E3631A-09B

SERVICE NOTE

E3631A DC Power Supply

On +6V output unit shows current draw without load

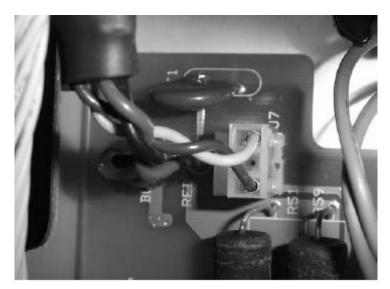
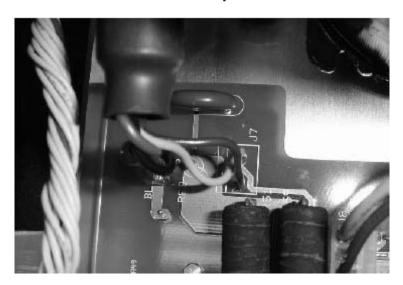
1. Solder the yellow and blue wires directly to J7 (part number: 1252-2786) on the E3631-60004 (Bottom PCA Board). Below pictures are showing the changes being performed.

Before – Yellow and Blue wires are connected to PCB with a connector jack.

Solution – Yellow and Blue wires are soldered directly to J7.

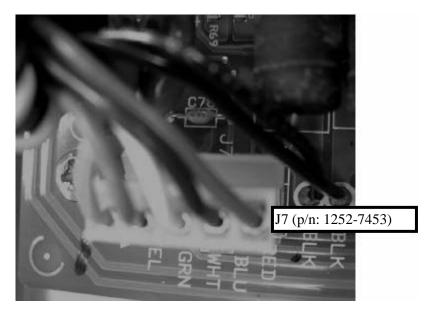
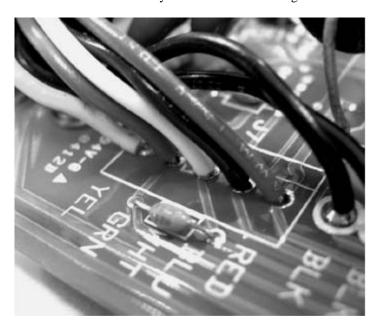
2. Remove J7 (part number 1252-7453) and solder the wires directly onto the PCB according to the colors indicated on the E3631-60002 (Top PCA Board).

Before – All 5 wires are connected to PCB within a connector jack.

Solution – All 5 wires are soldered directly to PCB board according to the indicated colors.

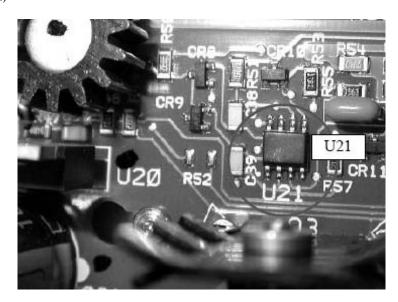
3. Change the U21 from part number 1826-1862 to part number 1826-2420 on E3631-60002 (Top PCA Board)

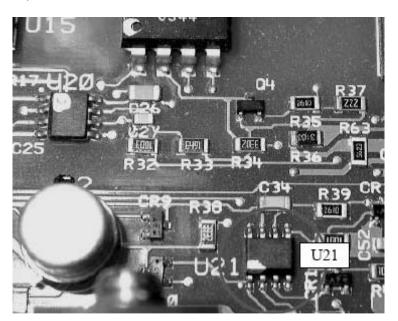
4. Change the U21 from part number 1826-1862 to part number 1826-2420 on E3631-60004 (Bottom PCA Board)

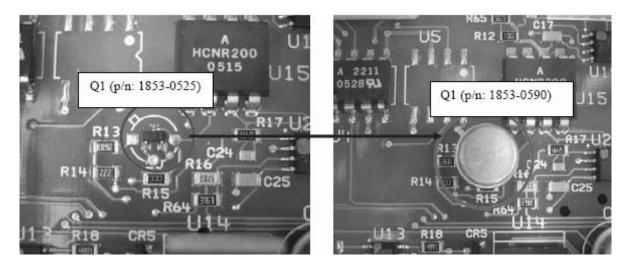
5. Change transistor Q1 from part number 1853-0525 to 1853-0590 on E3631-60004 (Bottom PCA Board).

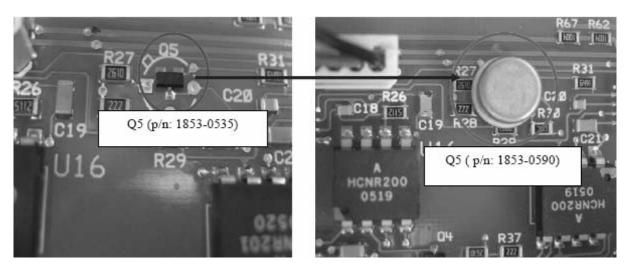
6. Change transistor Q5 from part number 1853-0525 to 1853-0590 on E3631-60004 (Bottom PCA Board).
